## NEEDHAM PLANNING BOARD Tuesday December 21, 2021 7:15 p.m.

# MAJOR PROJECT SITE PLAN REVIEW SPECIAL PERMIT AMENDMENT TO DECISION Application No. 2009-06

#### Town of Needham December 21, 2021

CONSTRUCTION DETAILS

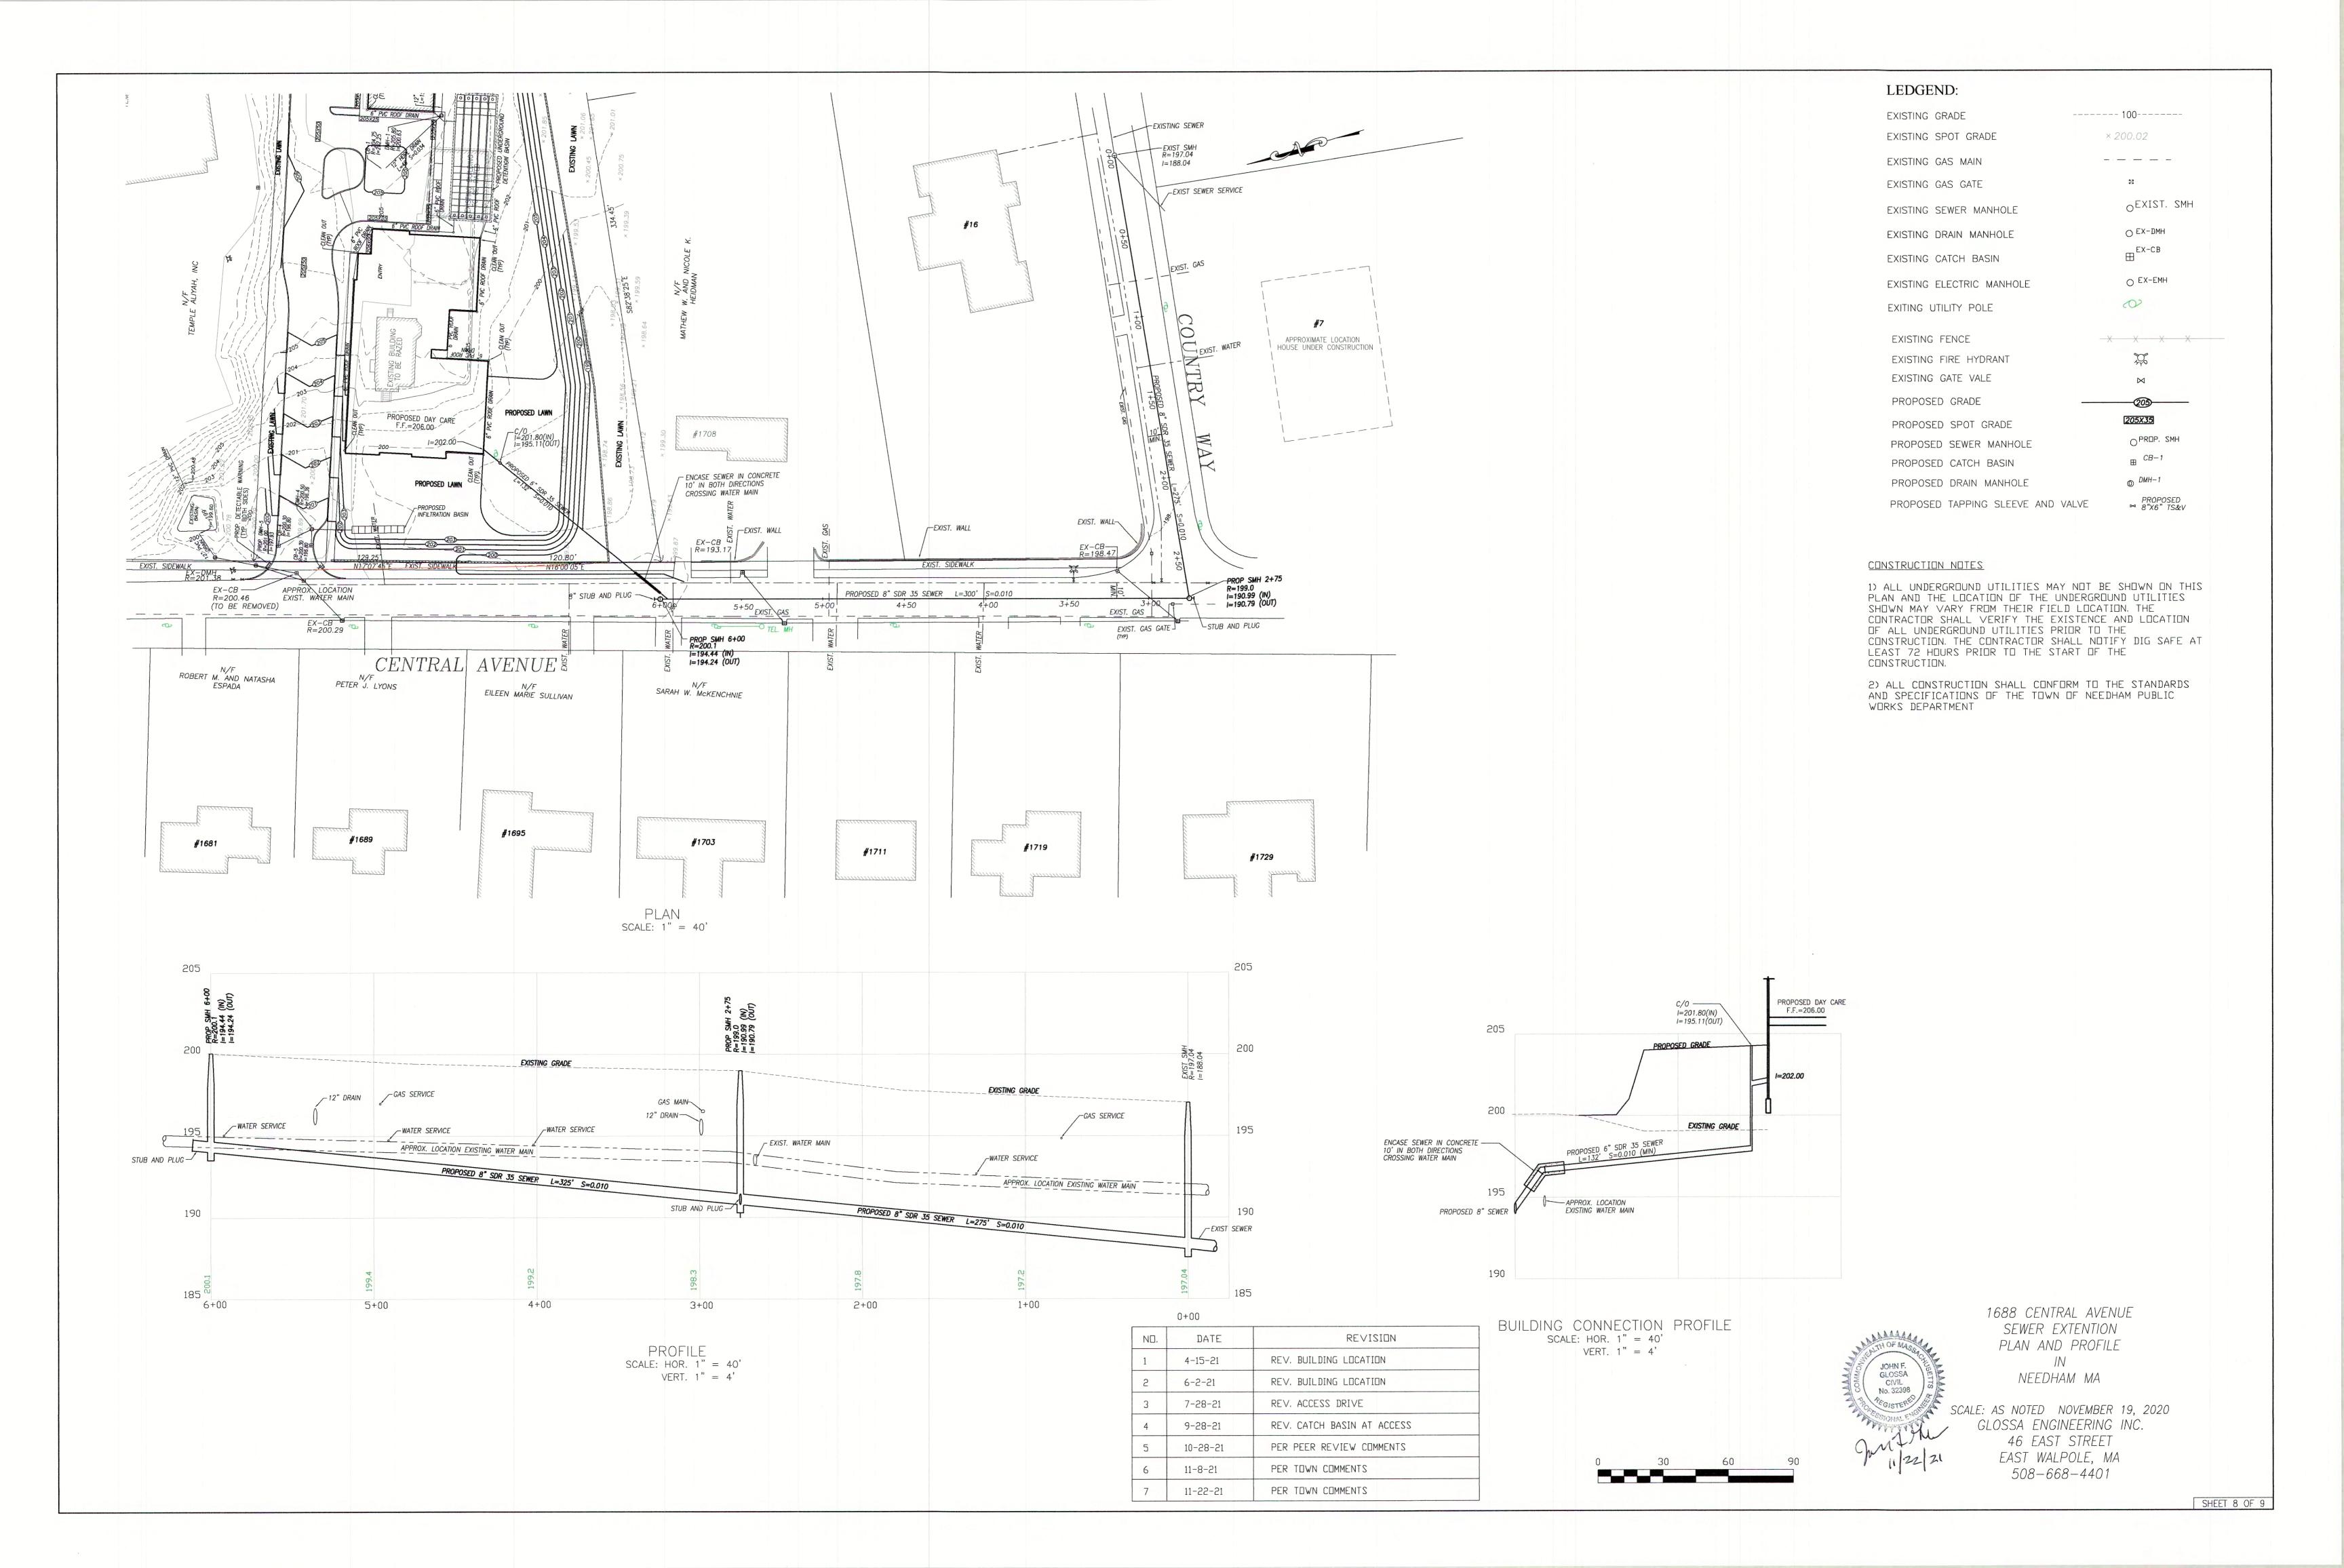
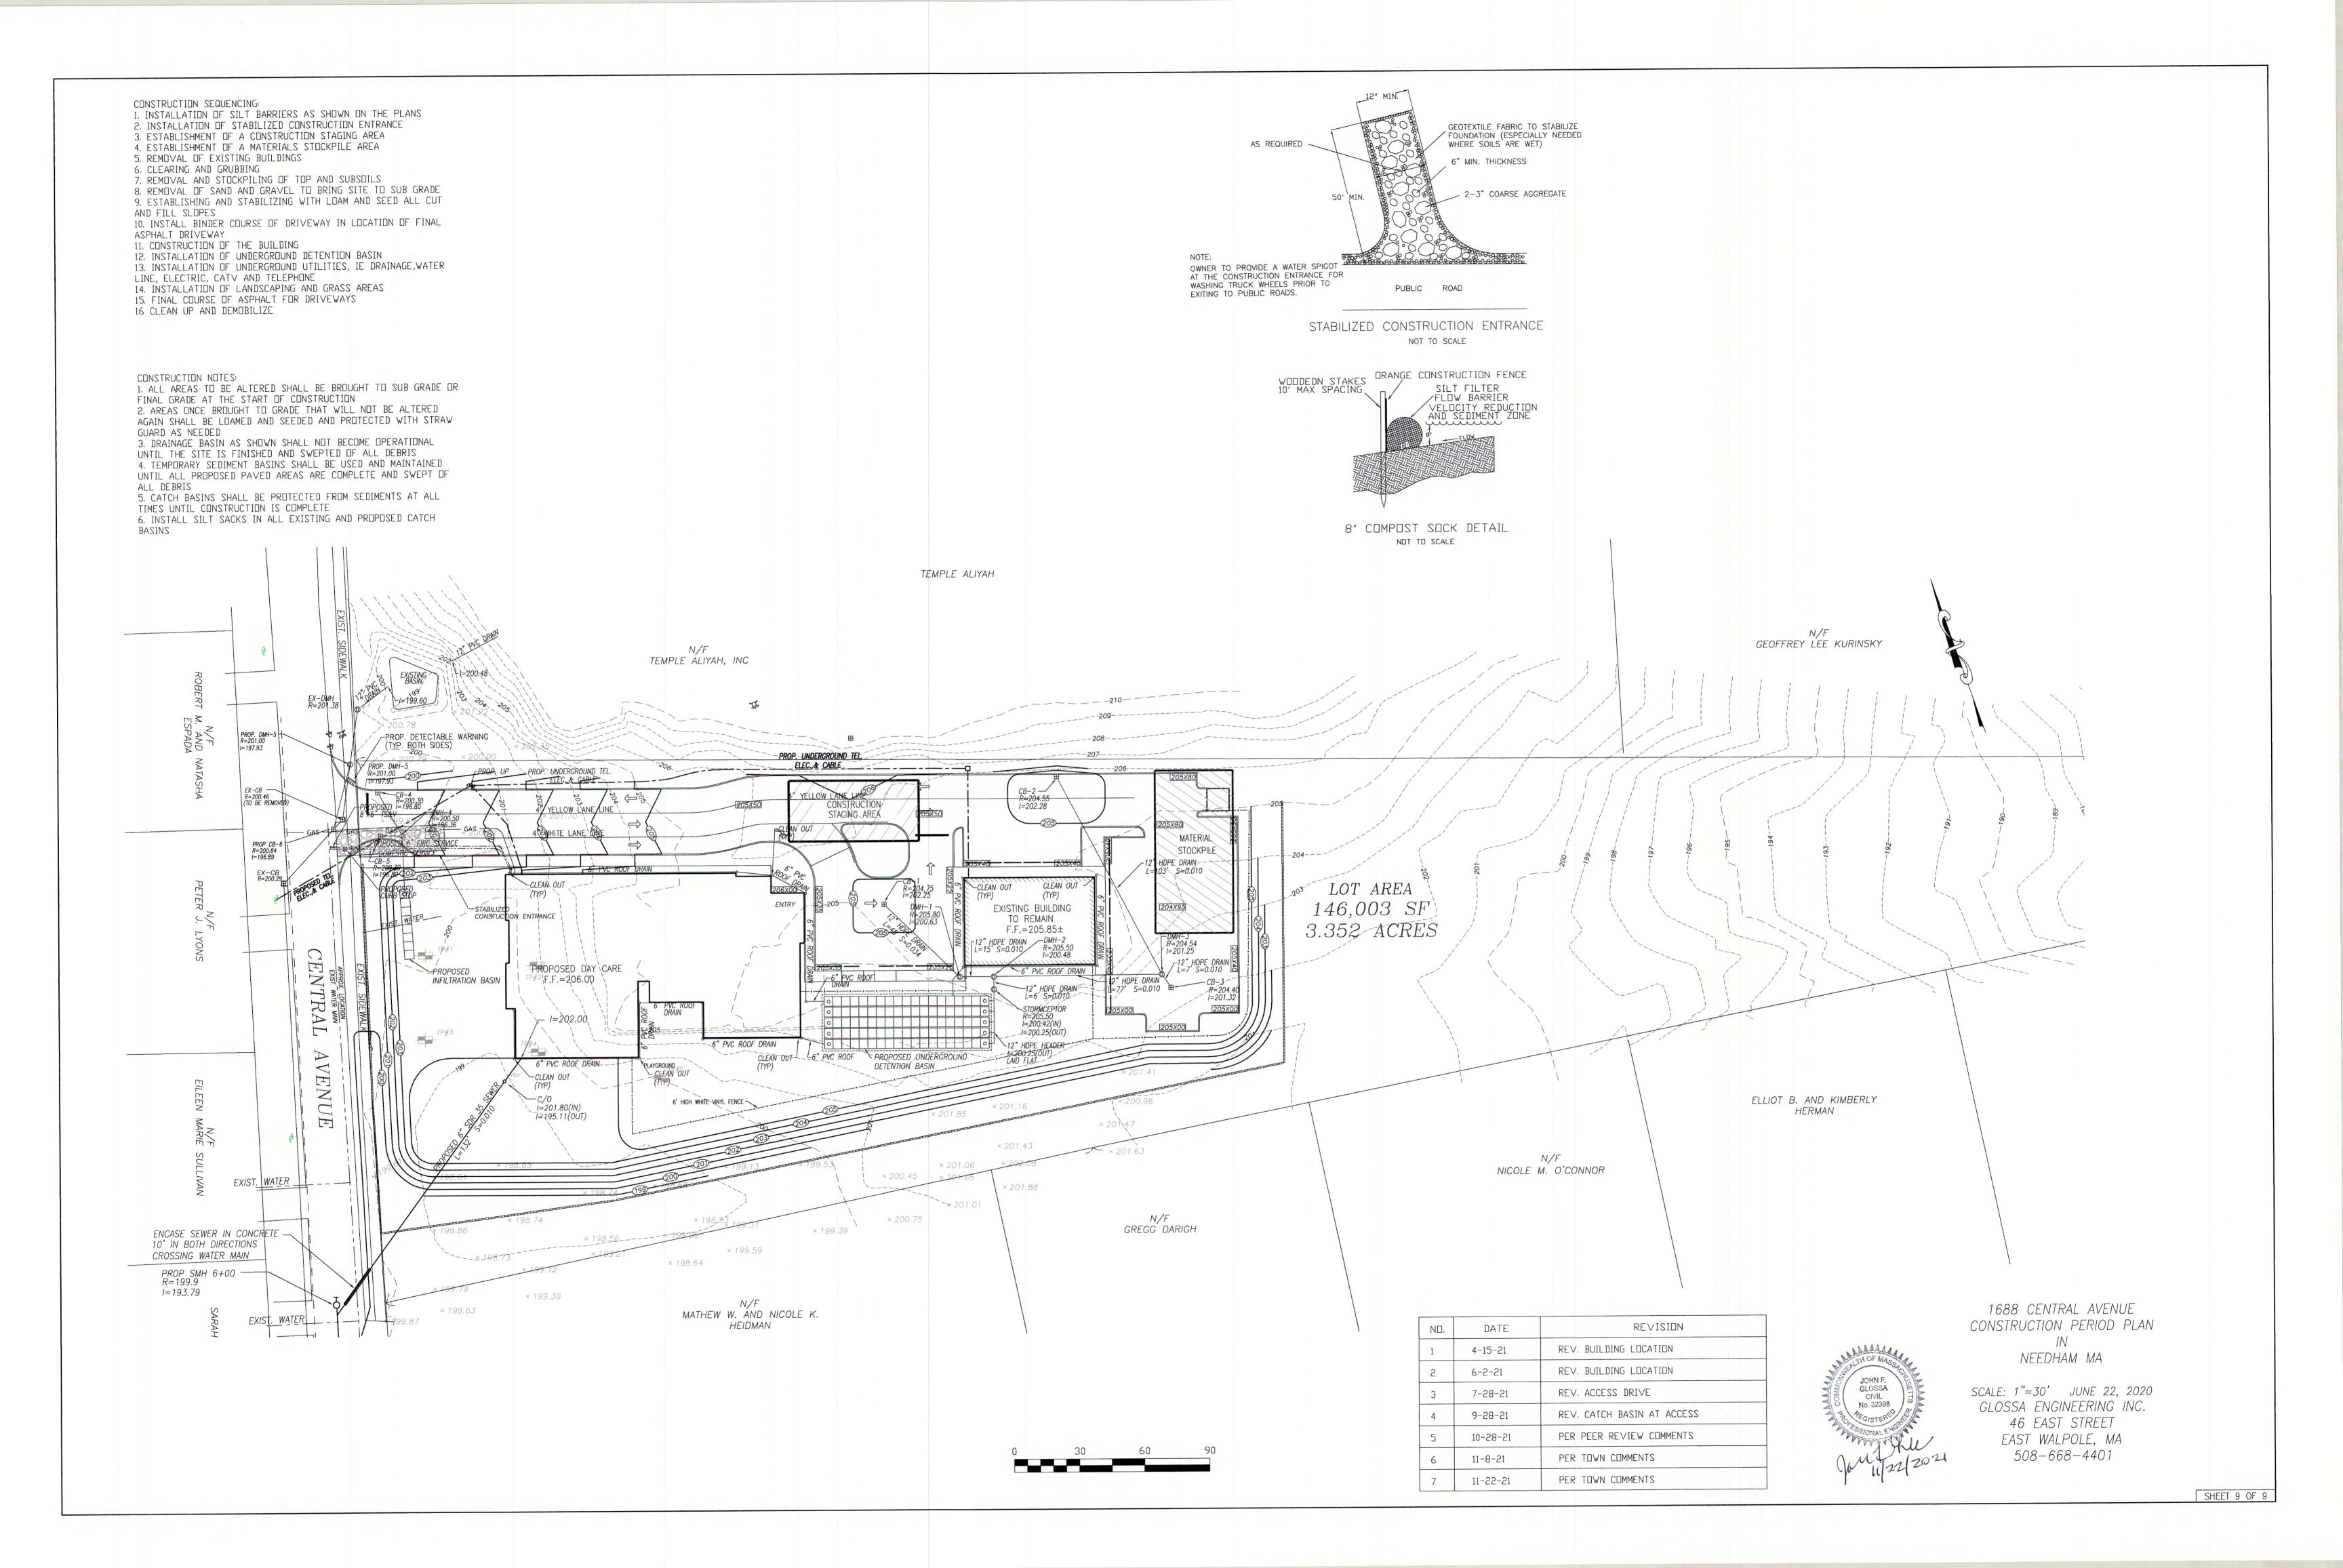
- a) Sheet 4 Proposed grades of the centerline of the driveway apron do not make sense. It appears to slope DOWN from the edge of road to the front of crosswalk by more than 2% and then slope up to the back of the crosswalk by more than 4%

- b) <u>Sheet 4 The spot grades 200x68 and 200x74 indicate the apron slope of about 1% UP at the sidewalk openings and a 1.8%-2.0% slope across the sidewalk/crosswalk, the apron portion should be sloped greater than the crosswalk portion.</u>

- c) Provide grades on sidewalk approaching driveway. It is unclear if the sidewalk slopes to the driveway or is level with the crossing.
- d) Sheet 4 Limit of work on the sidewalks should be indicated (also relates to Comment 2)

- e) Sheet 6 Detail should be provided for the proposed driveway apron.
- f) Sheet 8 & 9 Proposed CBs should be labeled and Existing CB to be removed should be labeled

- g) Sheet 10 Either delete labels on CBs (not relevant for lighting) or correctly label the Existing CB to be Removed
